digital		ORIGINATOR Tom Orr 1.2		ECO NO. <u>M7254-0001</u>																					
ENGINEERING CHANGE ORDER <u>9167</u>		TEL EXT 2791 DATE 11/17/72		SHEET <u>1</u> OF <u>1</u>																					
		DISC PROJ NO E20-06734		DATE RECEIVED <u>11-30-72</u>																					
		COST CENTER NO. <u>378</u>		FIRST ISSUE <u>12-14-72</u>																					
				FINAL ISSUE <u>12-17-72</u>																					
PROBLEM				UNIT TO BE CHANGED																					
1) RK11-D samples word count overflow at sector end time to determine if a transfer is complete. This gives premature termination of write and write check functions during short sectors.				M7254																					
2) Temporary availability problems with T.I.7427 #19-10870				Etch																					
CORRECTION				Rev. C																					
1) Use file done signal from M7256 instead of word count overflow for sample at sector end.				DISC CODE 03																					
2) Add 8875 #19-10647 to parts list as an alternative to 7427.				OPTIONS AFFECTED																					
BREAK-IN/EFFECTIVITY				RK11-D,E																					
Rework all M7254 Rev C boards.				PRODUCT LINES AFFECTED																					
				PDP-11																					
IT

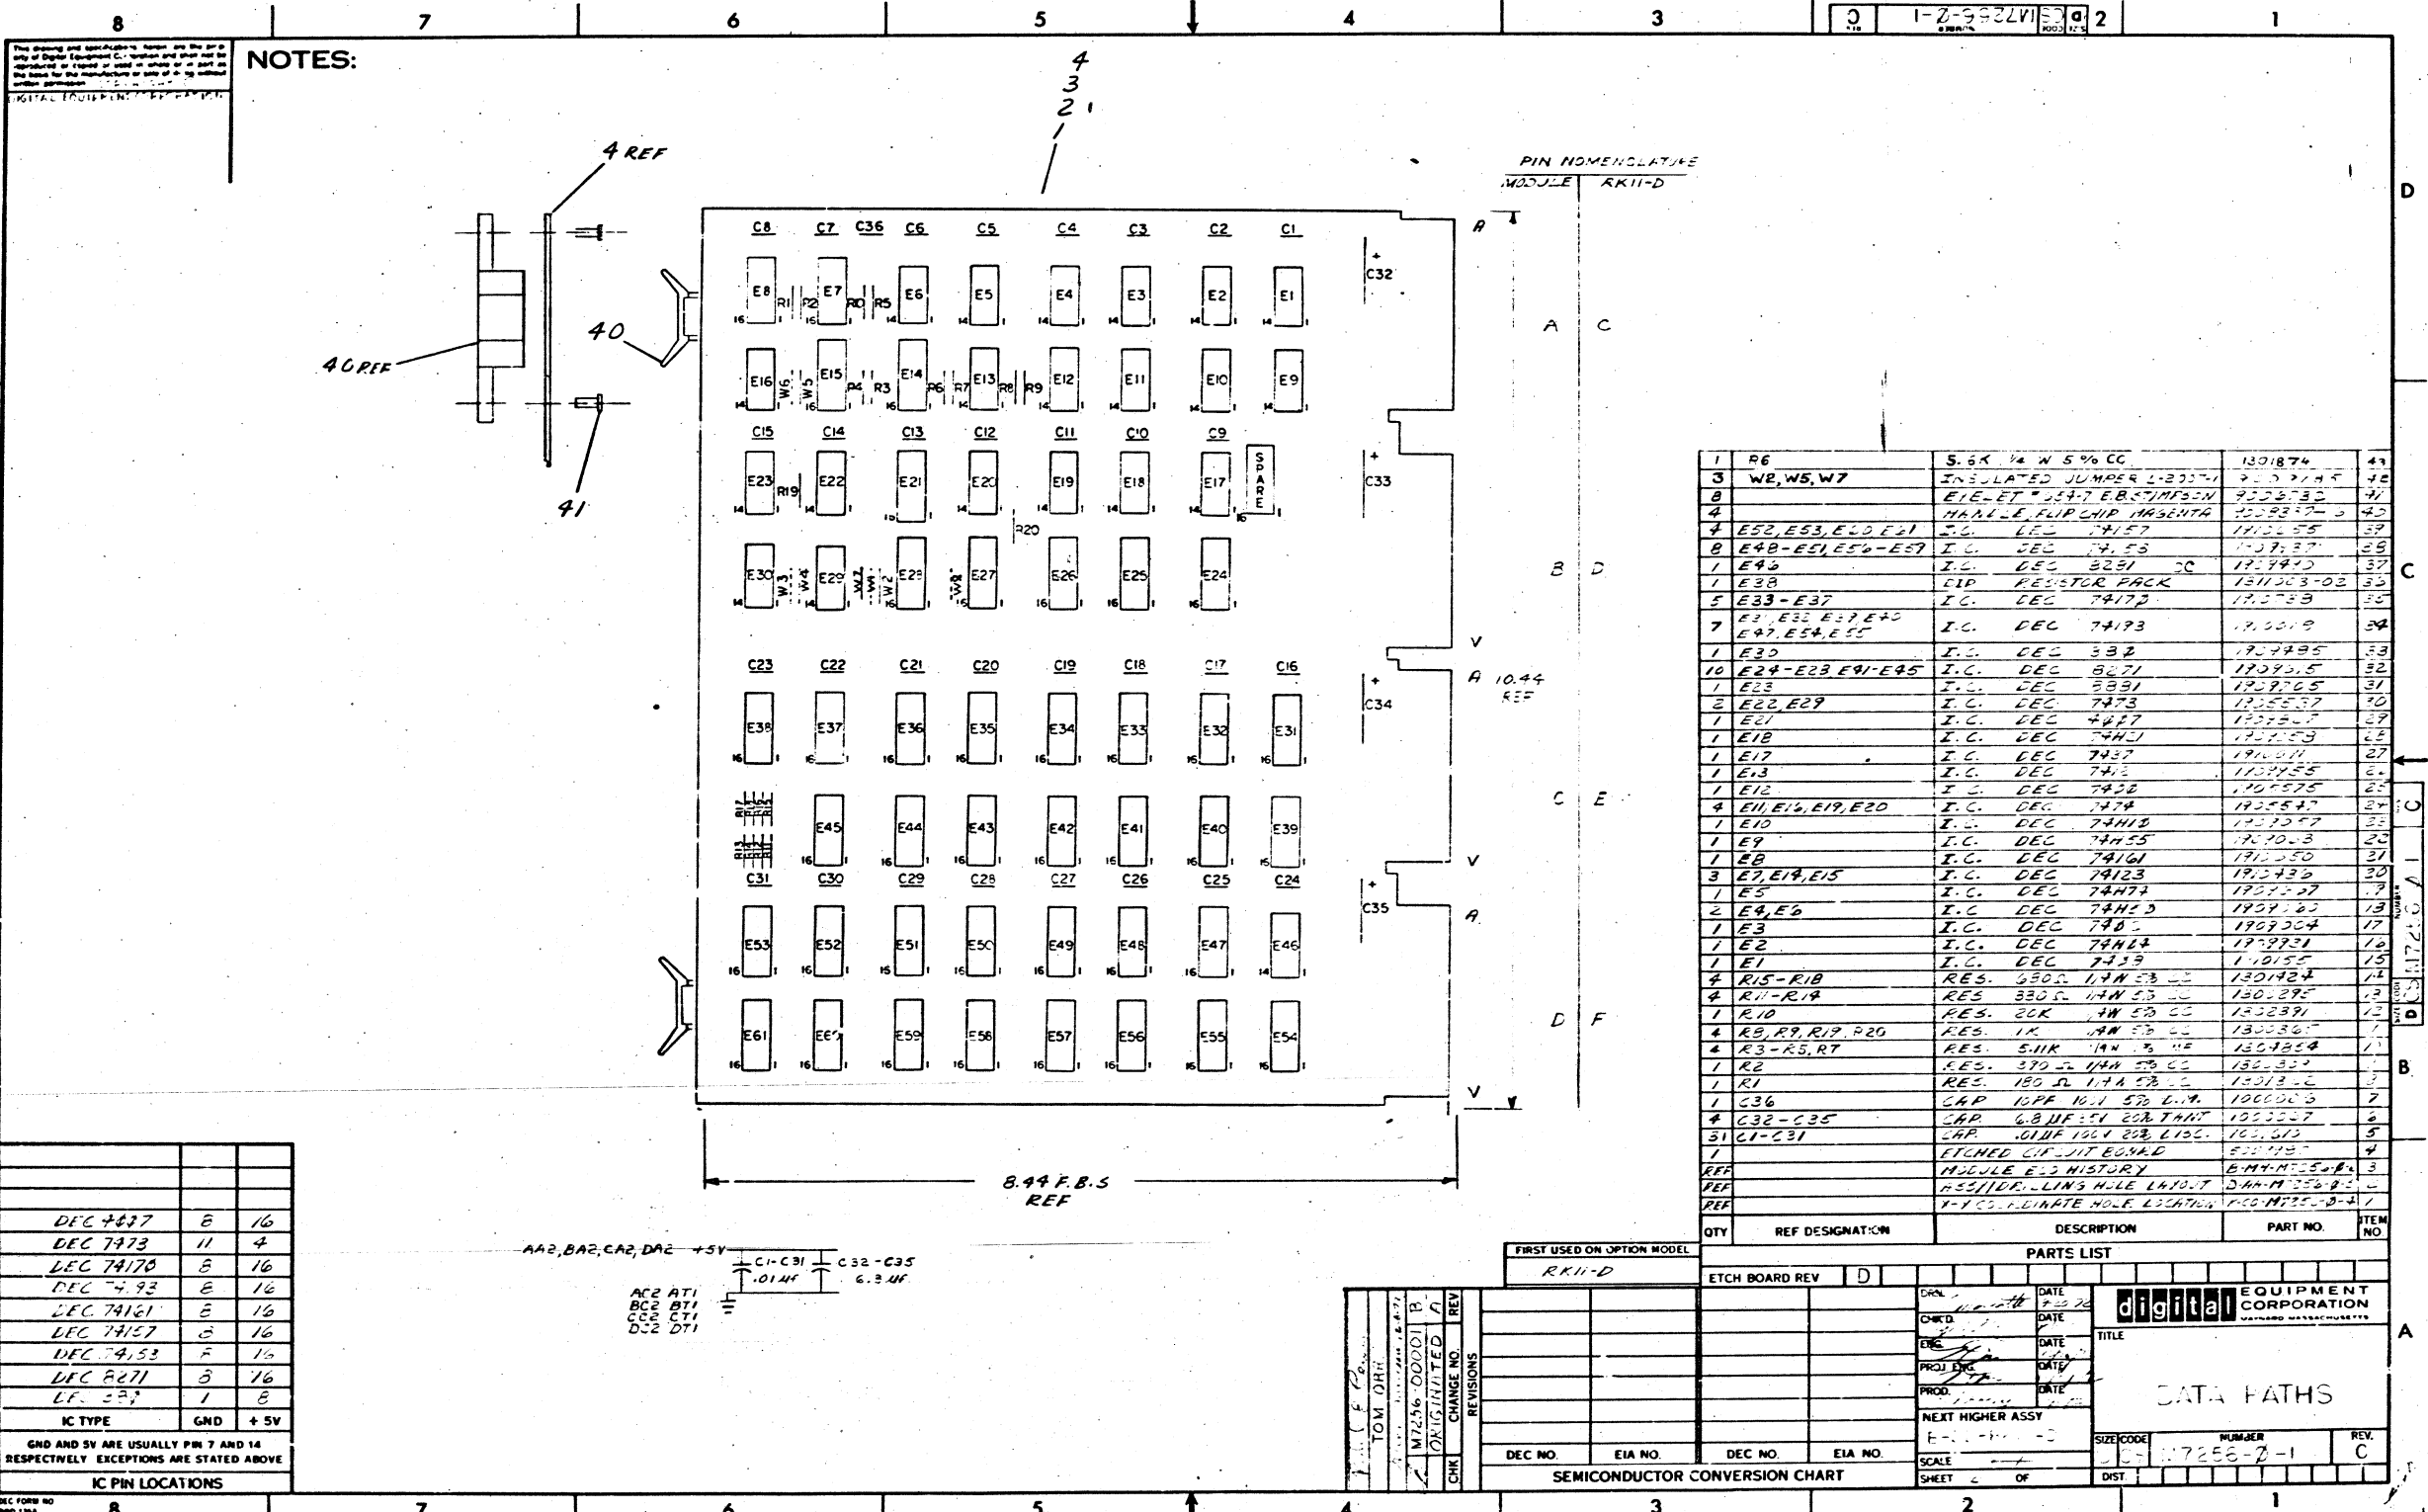
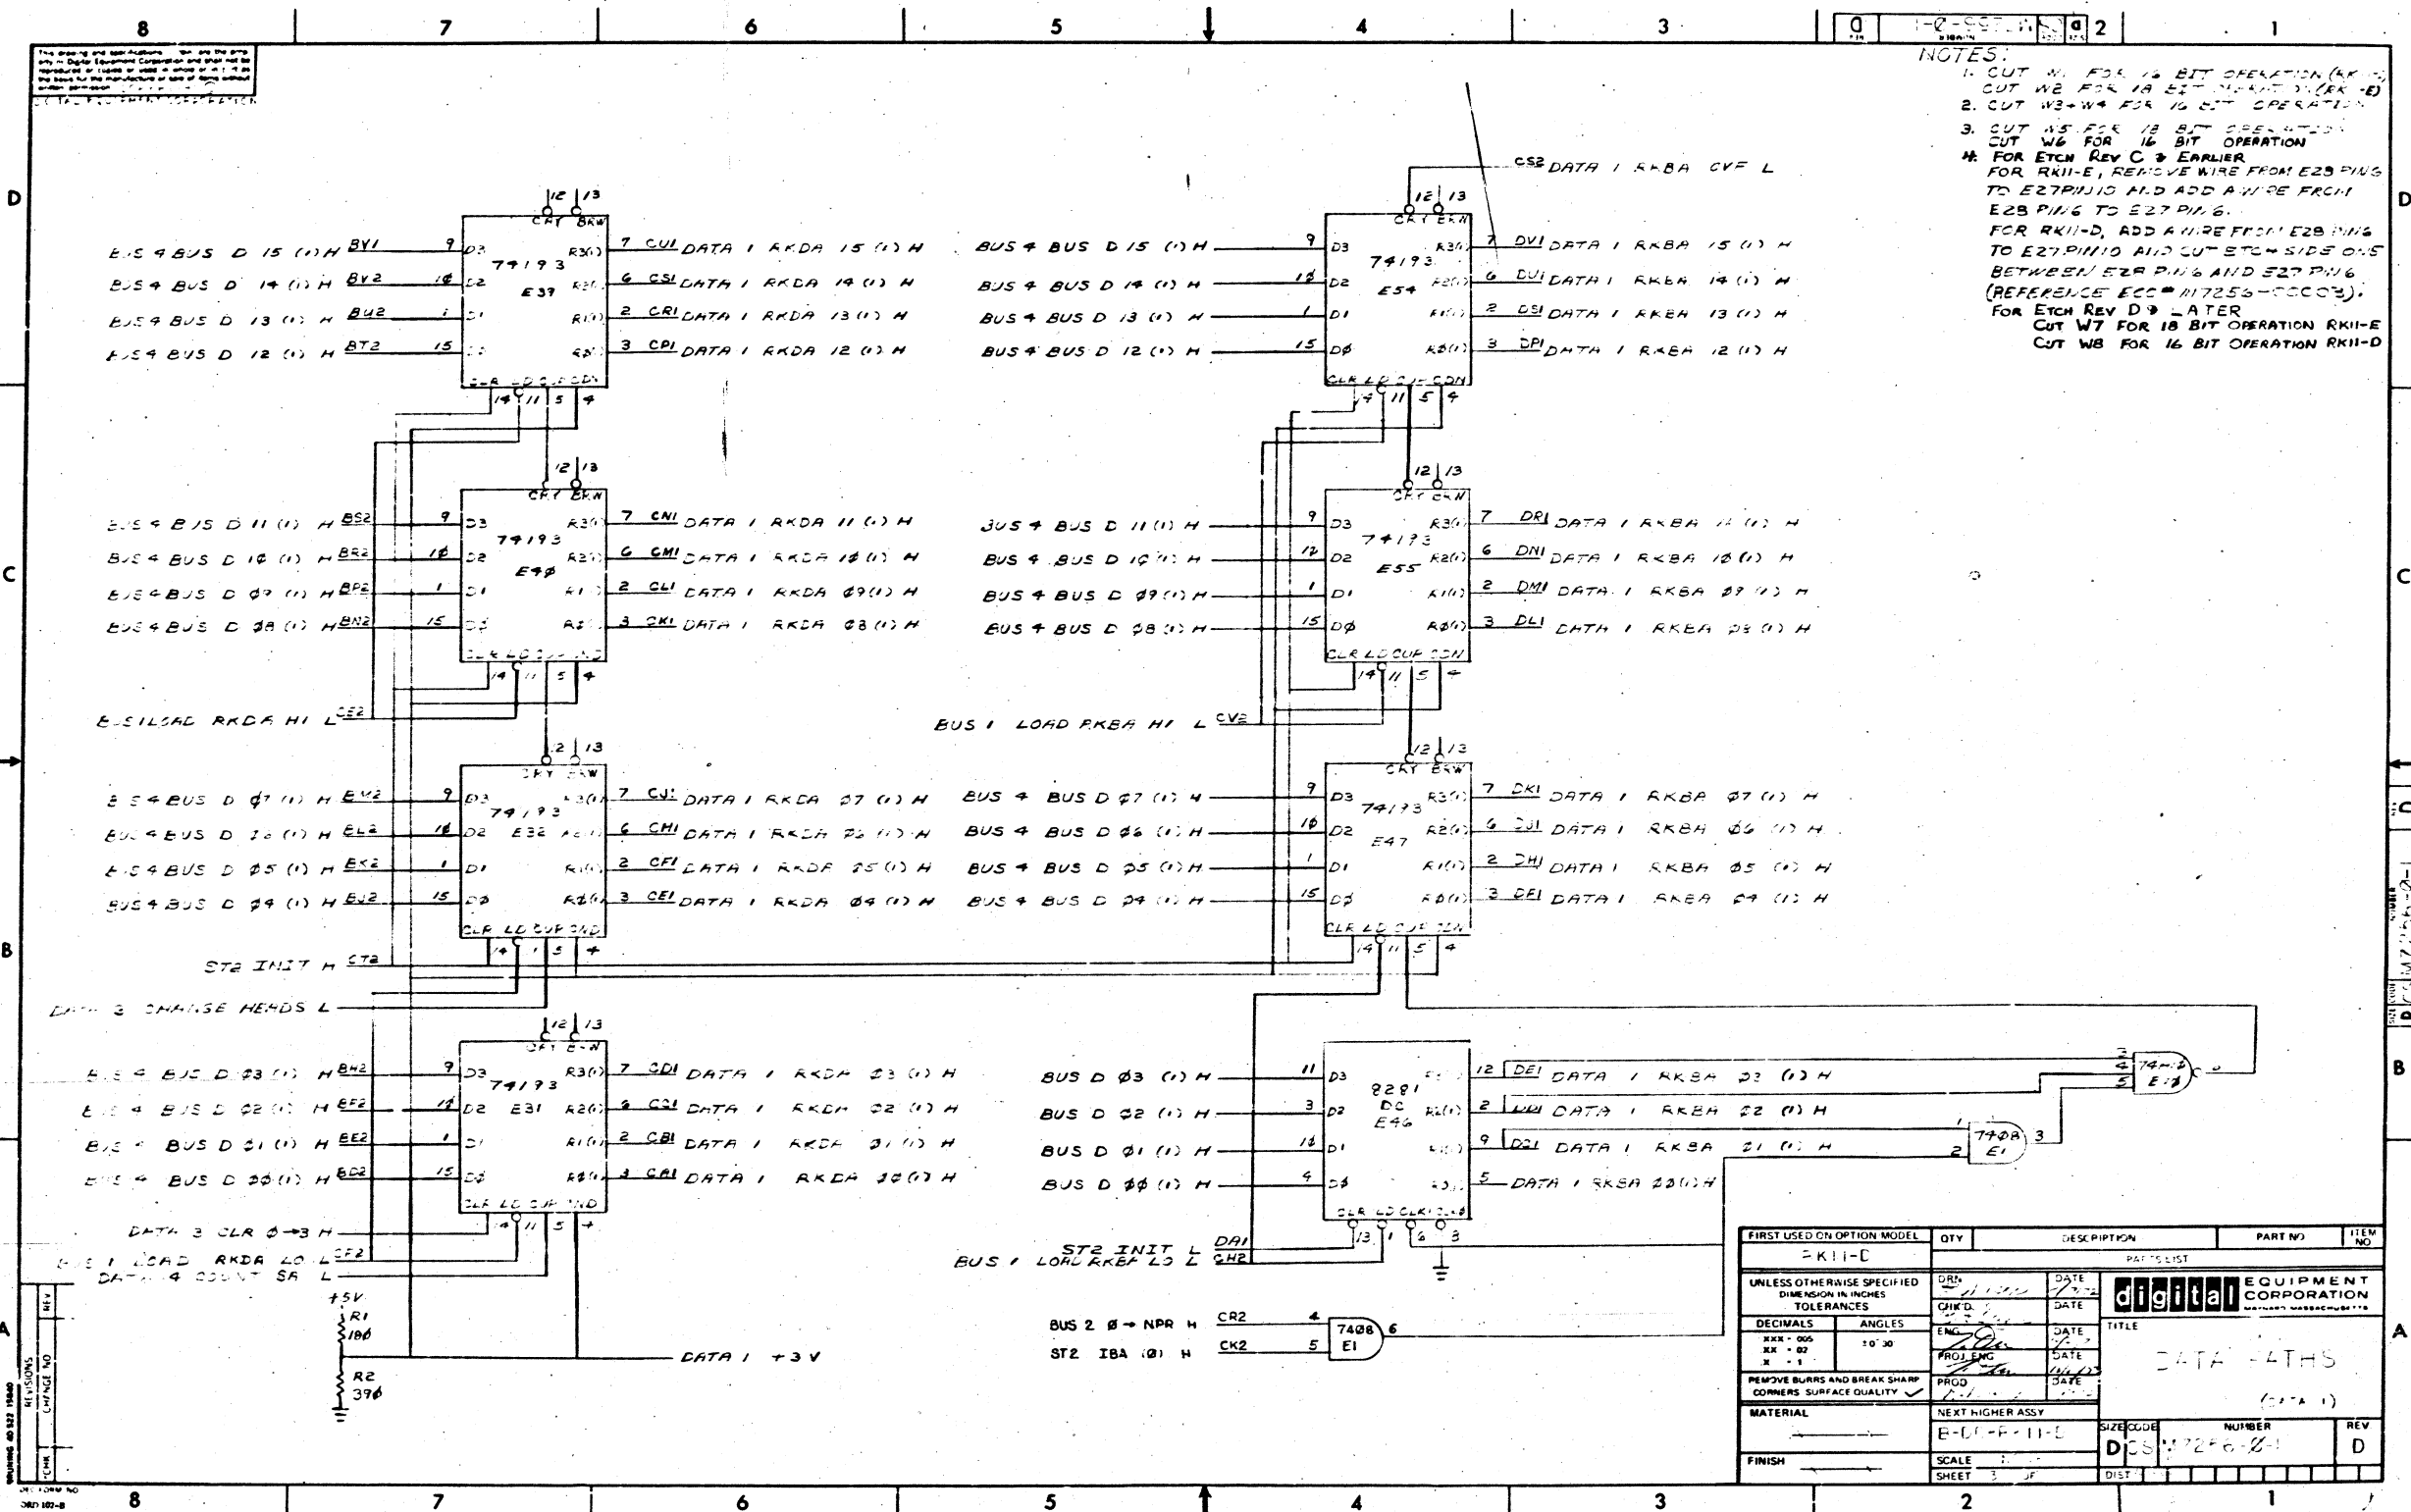
2.	B-MH-M7256-0-6	C	D	06	See final release drawing.
3.	D-AH-M7256-0-5	D	E	06	Correct etch to include jumpers W8 and 7 as shown on D-CS-M7256-01, sheet 7.

4.	5009987	C	D	02	Correct etch to include jumpers W8 and 7 as shown on D-CS-M7256-0-1, sheet 7.
5.	9009185	-	-	-	INSULATED JUMPER. DELETE THREE FROM PARTS LIST
DISPOSITION CODES				APPROVAL SIGNATURES	
00 - RETURN TO STOCK 01 - (DELETED) 02 - USE PRESENT STOCK UNTIL NEW STOCK AVAILABLE (REUSE IN) 03 - REWORK IMMEDIATELY (RETROFIT) 04 - (DELETED) 05 - (DELETED) 06 - DOCUMENT CORRECTION 07 - NEW ITEM (THIS ASSEMBLY) 08 - NEW ITEM (THIS COMPANY) 09 - SCRAP IMMEDIATELY				Type/Title: <u>DESIGN ENGR TOM OFF</u> Hand Signature: <u>[Signature]</u> 1-2 DESIGN ENGR (OPT) FIELD SERVICE (OPT) CHIEF ENGR (MODULES ONLY) <u>[Signature]</u>
